California Public Utilities Commission

Re: *Minor Project Refinement No. 3 for the Power Santa Clara Valley Project (A.24-04-017)*

Power Santa Clara Valley Project CPUC Minor Project Refinement Form

POWER SANTA CLARA VALLEY PROJECT
MPR-3 Julian Street
Downtown Route Alignment
City of San José, and Santa Clara Co., CA

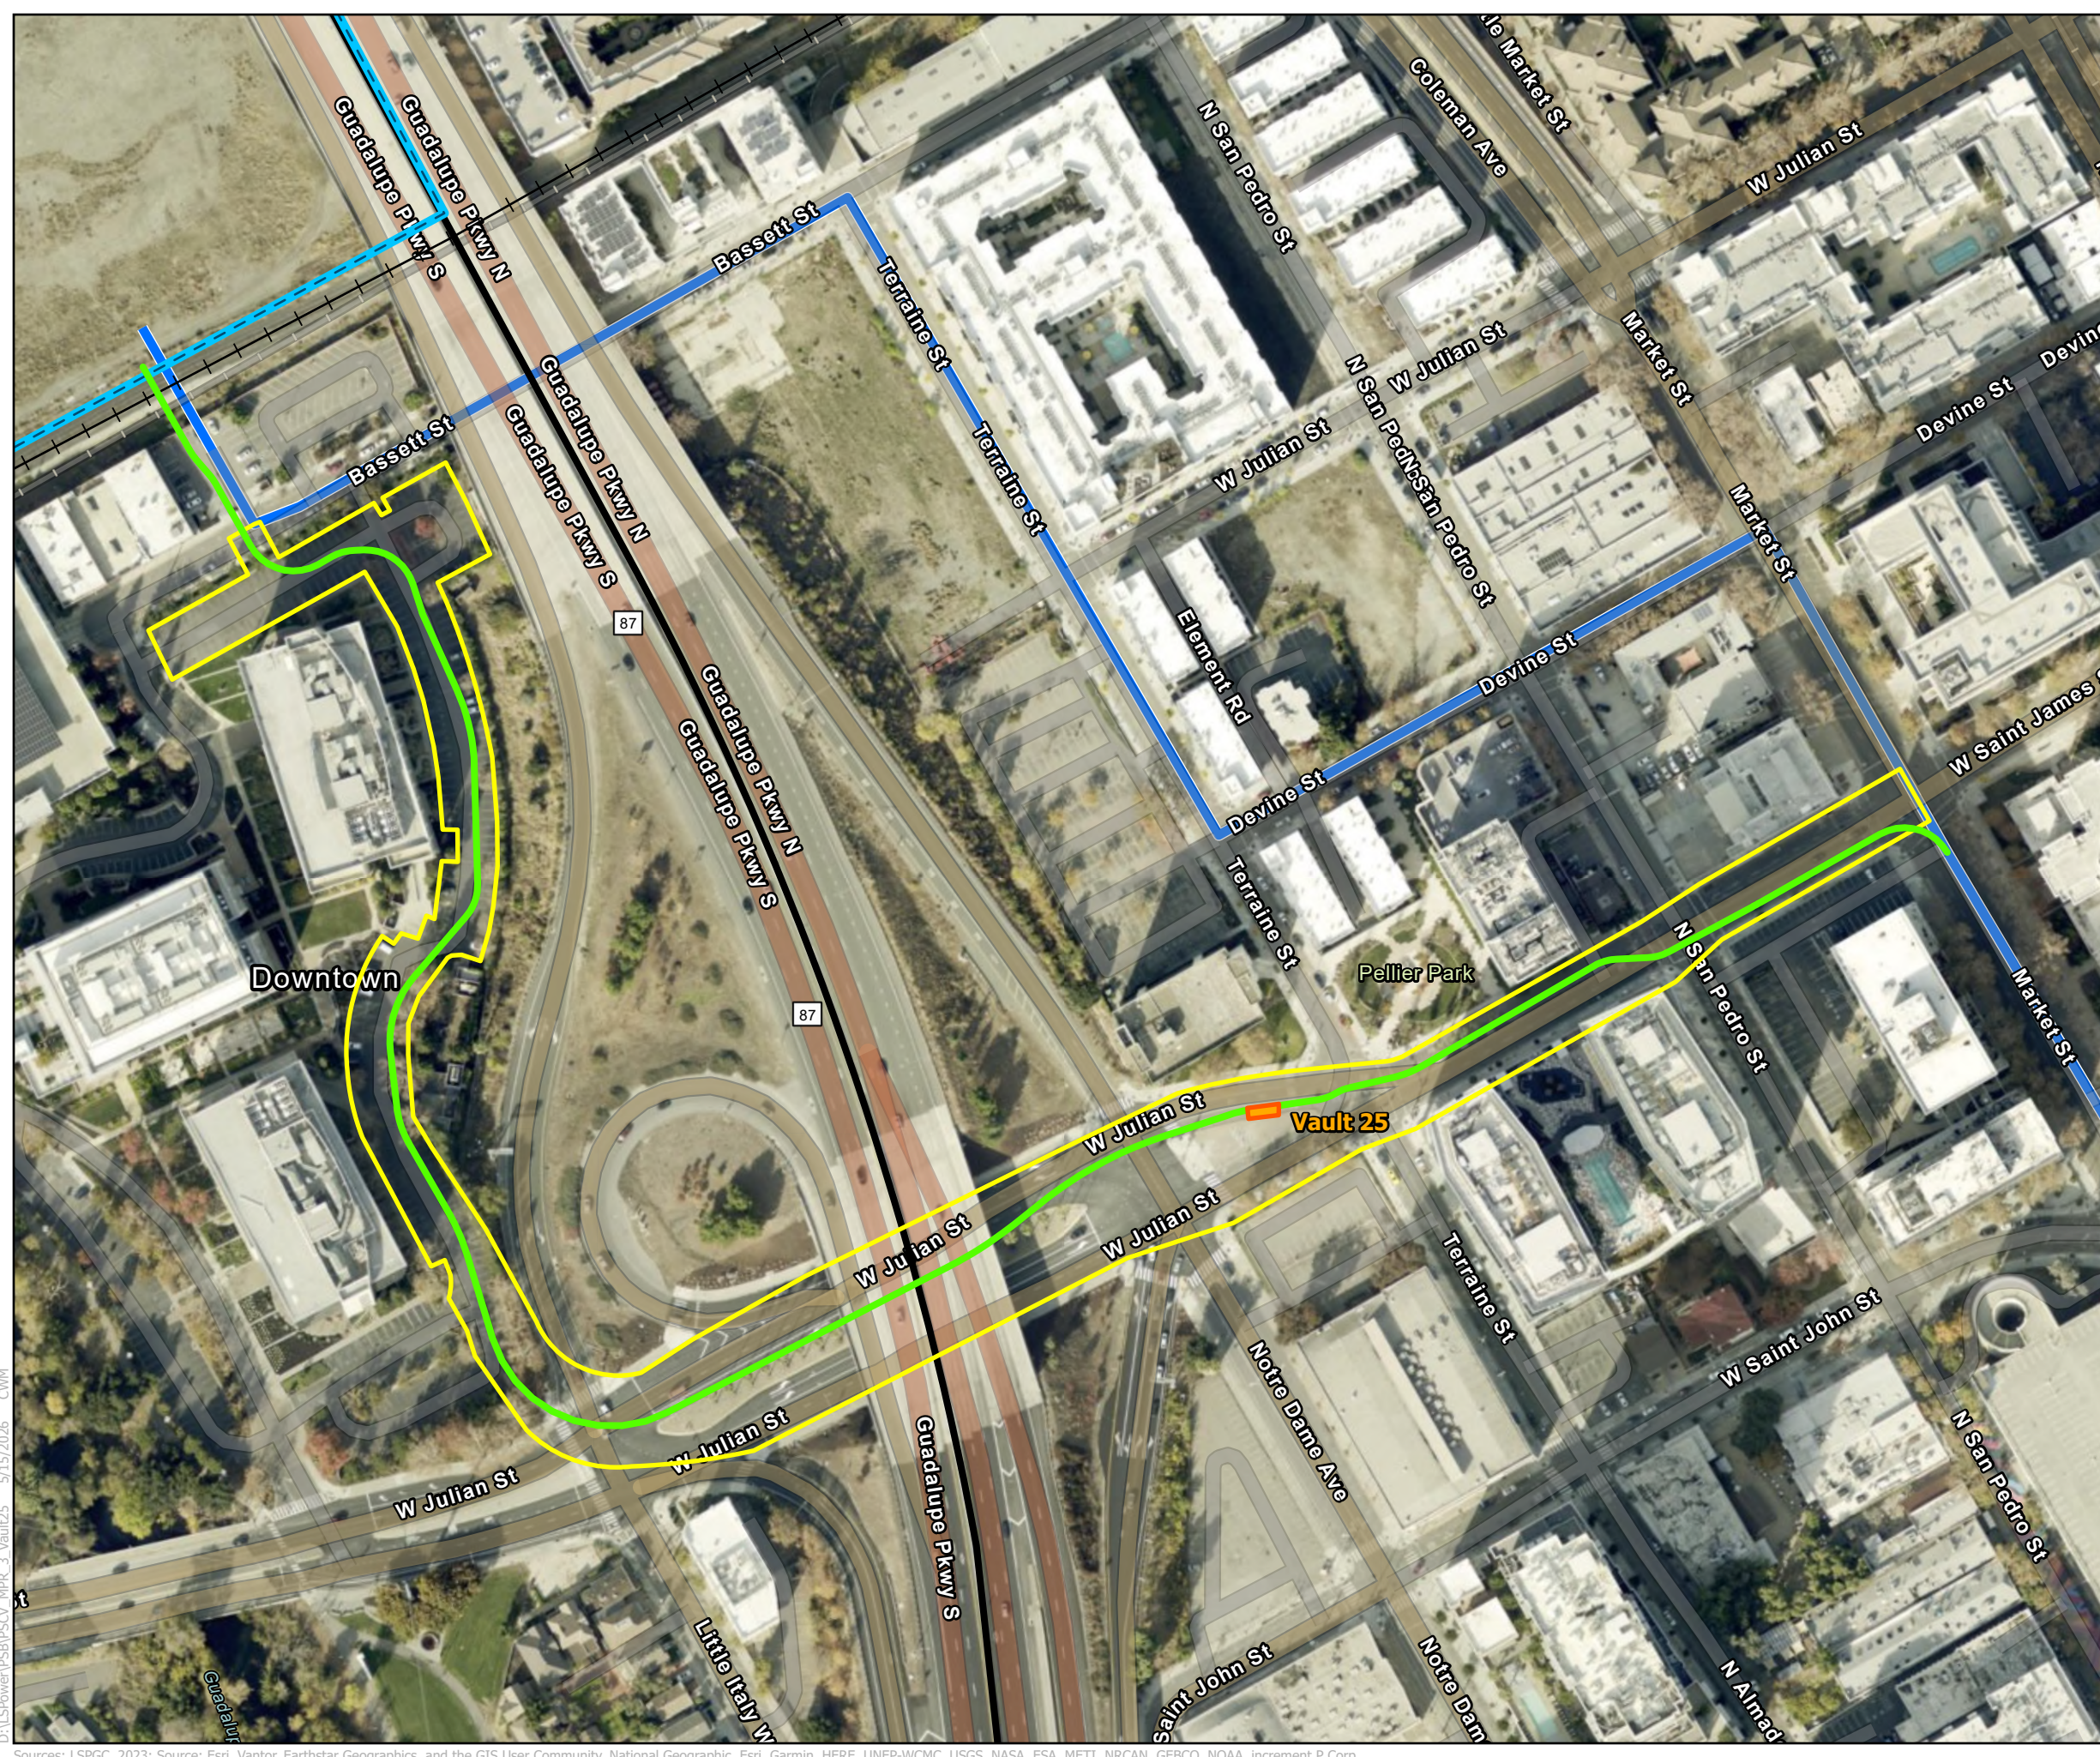
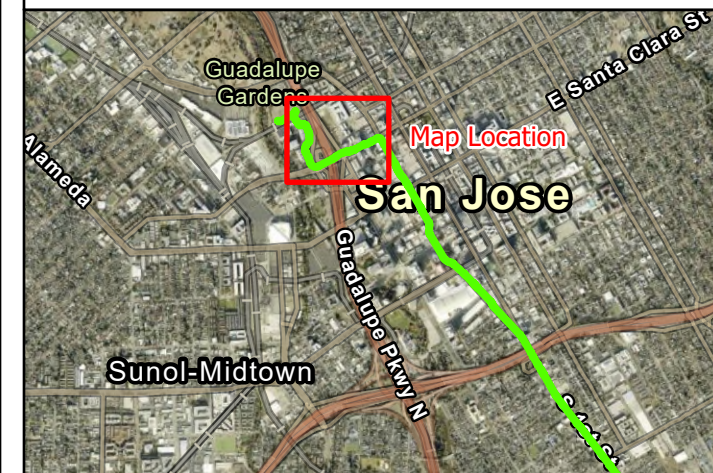
LS Power Grid California, LLC (LSPGC) is requesting approval of MPR-3 for a minor route adjustment to the Grove to Skyline 320 kilovolt (kV) direct current (DC) Transmission Line (Grove to Skyline 320 kV Transmission Line), which was described as the Downtown Alignment Alternative 2 analyzed in the Power Santa Clara Valley Project (Project) Final Environmental Impact Report (FEIR), as described below and shown in Attachment B, MPR-3 Figure.

LSPGC proposes to **utilize the FEIR's** Downtown Alignment Alternative 2 and reroute approximately 0.5 miles of the Grove to Skyline 320 kV Transmission Line in order to avoid conflicts with existing underground utilities along the approved route. Due to the constrained urban environment and existing subsurface infrastructure within downtown San José, final engineering investigations were necessary to identify a constructible alignment. Beginning at the

intersection of North Market Street and West Saint James Street, the MPR-3 route travels west along West Saint James Street, which turns into West Julian Street, for approximately 0.3 miles, and then turns northwest to enter the parking lot of a privately owned office complex, currently leased to Santa Clara County. The revised route continues north through the parking lot for approximately 0.2 miles until it aligns with the approved Grove to Skyline 320 kV Transmission Line route at Bassett Street, consistent with Downtown Alignment Alternative 2 (FEIR Figure 4-5). The proposed MPR-3 route is located entirely in the City of San José, within paved and developed areas similar to the approved route. Existing land uses surrounding the MPR-3 route consist of commercial, industrial, and residential, similar to the approved route segment that MPR-3 would replace. Between the Skyline Terminal site and the intersection of North Market Street and West Saint James Street, the proposed MPR-3 route is approximately 0.53 miles long, whereas the approved route is approximately 0.49 miles long.

LSPGC is authorized to proceed with the proposed route as described in its MPR-3 request to CPUC submitted on May 20, 2026, upon condition that all proposed actions and construction are carried out in accordance with the methods and conditions described in the FEIR, Construction MMCRP, the MPR-3 request, and this approval issued by CPUC.

Conditions of Approval or Reason for Denial:
All proposed actions and construction are carried out in accordance with the methods and conditions described in the FEIR, Construction MMCRP, the MPR-3 request, and this approval issued by CPUC.
